7 February 2025

Mr Daniel Westerman
Chief Executive Officer
Australian Energy Market Operator

Submission to Draft 2024-25 GenCost

Figure 13: Comparison of 2020 ISP and 2024 ISP transmission cost estimates

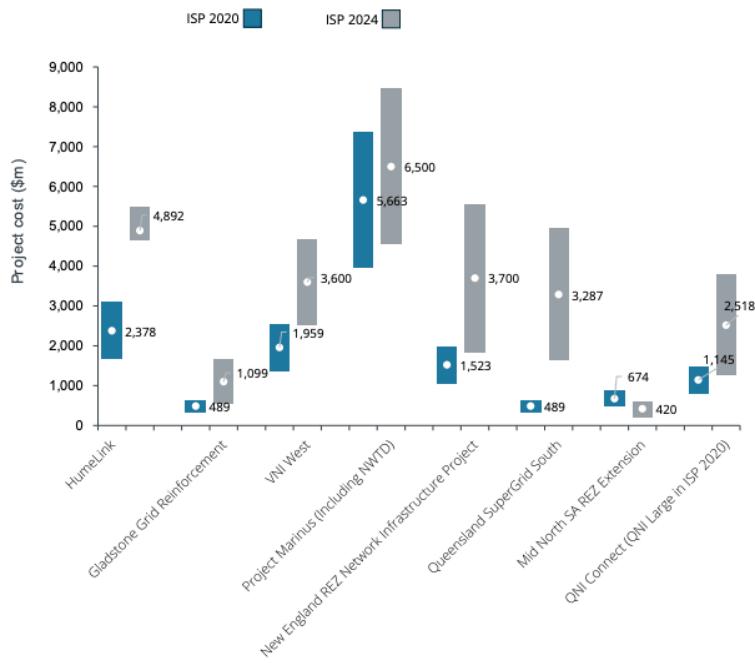
Between REZ and other transmission, GenCost accounts for the total cost of transmission in the 90% VRE scenario for 2024 as \$23/MWh. This figure is impossible to verify as GenCost does not reveal which transmission projects are included in this figure.

Transmission costs are notorious for blowouts. Frontier Economics has shown that initial cost estimates for transmission projects in the 2020 ISP have consistently underestimated the revised 2024 cost estimates.⁹ The ISP does not include committed or anticipated transmission projects in the costs. Given that the authors of GenCost consider the ISP as a benchmark, they are likely to be underestimating the cost of transmission projects as well.

Figure 7 Forecast VRE generation and spilled or curtailed energy 2024-25 to 2049-50, Step Change (TWh)

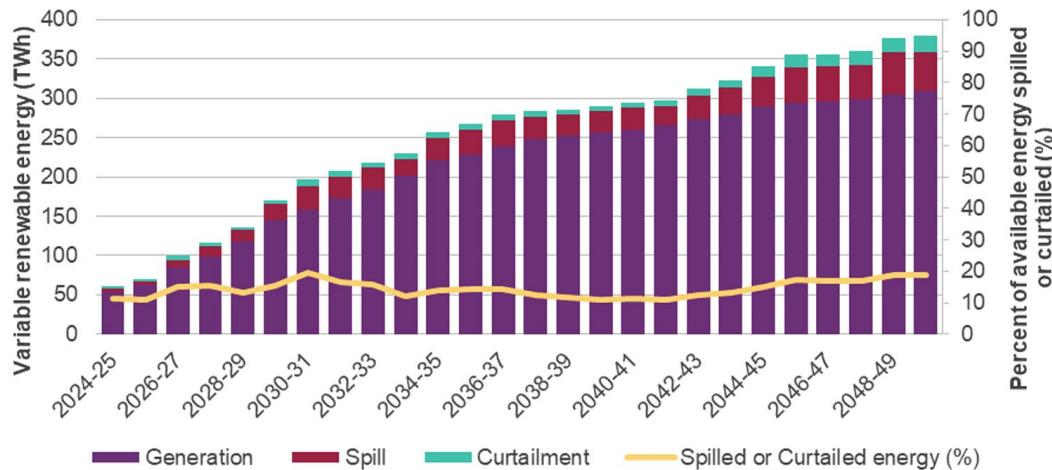
Not only is there a clear contradiction in spillage costs, but there is a significant departure from the amount of spillage as a percentage of generation from the ISP. GenCost assumes spillage to equate to only 5% of generation. The ISP forecasts a much higher amount of spillage as a proportion of generation — closer to 12%.¹¹

AEMO's curtailed energy forecasts are already optimistically biased; smoothed by assumed-to-be-built hydrogen solar sinks and a significant uptake of coordinated consumer storage. It is unclear how GenCost assumes less than half the percentage of energy wasted than the ISP. If curtailment was forecast in GenCost closer to the 12% proportion of generation — as outlined in the ISP — the cost estimates for renewables would increase. CSIRO should publish the data to clarify the peak spillage costs at the 90% VRE share, and the assumptions and modelling behind the spillage percentage of generation which undercuts the already optimistic ISP projections.

Figure 1 Forecast average annual demand profile for the NEM, 2024-25 and 2039-40, Step Change (GW)

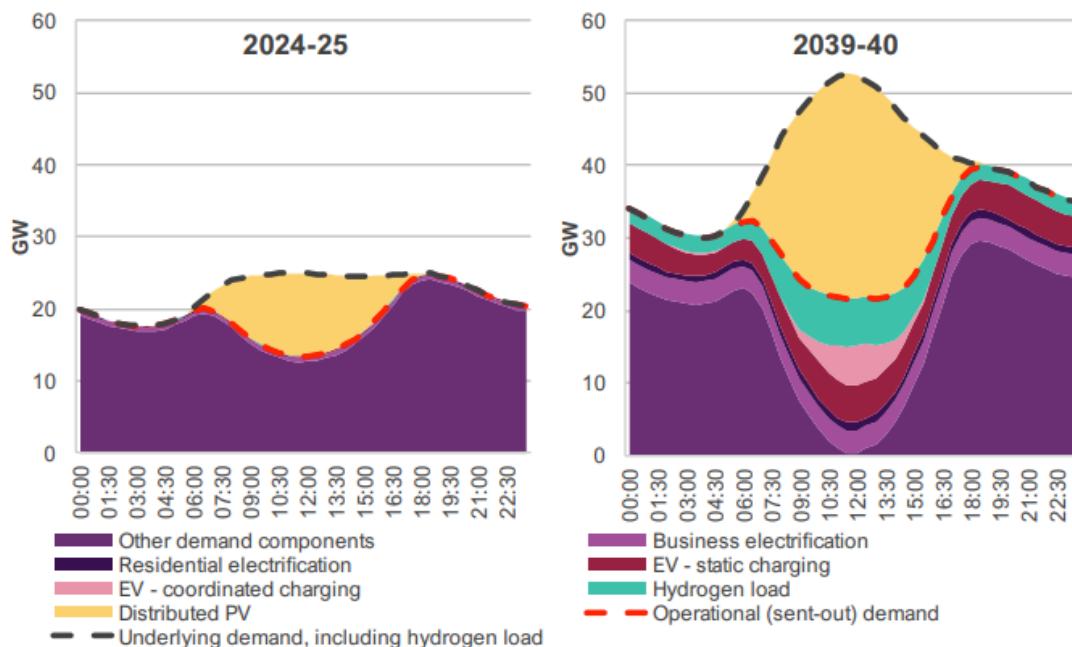
Appendix 4 of the 2024 ISP outlines the duck curves for the demand load profile of the NEM in Step Change. In the 2040 figure, the curve is softened, due to behavioural consumption patterns, static EV charging, business electrification and hydrogen. These are not included in the costs of the ISP, so inheriting overly-optimistic assumptions of the demand profile in GenCost are likely to result in an artificially low LCOE of renewables.

Despite GenCost stating that 90% VRE share excludes rooftop PV,¹³ it is unclear whether it is including its impact (alongside CER) in the demand load forecasts if they are modelled from the ISP. If CSIRO is indeed adopting AEMO's demand load profile without adjustment, there is a risk that GenCost inadvertently imports optimistic assumptions from the ISP. These assumptions may include high CER uptake and hydrogen solar sinks, which together smooth out demand load profile variances and reduce projected system costs. This risks masking the true challenges and expenses associated with integrating high levels of VRE.

CSIRO should explain how its demand-load profile differs from AEMO's. CSIRO should explicitly detail how CER, hydrogen, and EV uptake assumptions influence demand profiles. A sensitivity analysis should quantify costs under alternate scenarios, such as delayed CER adoption. GenCost's demand forecasts must be distinct from the ISP, avoiding reliance on its policy-driven inputs. This includes modelling rooftop solar's full impact on residual demand and infrastructure requirements.
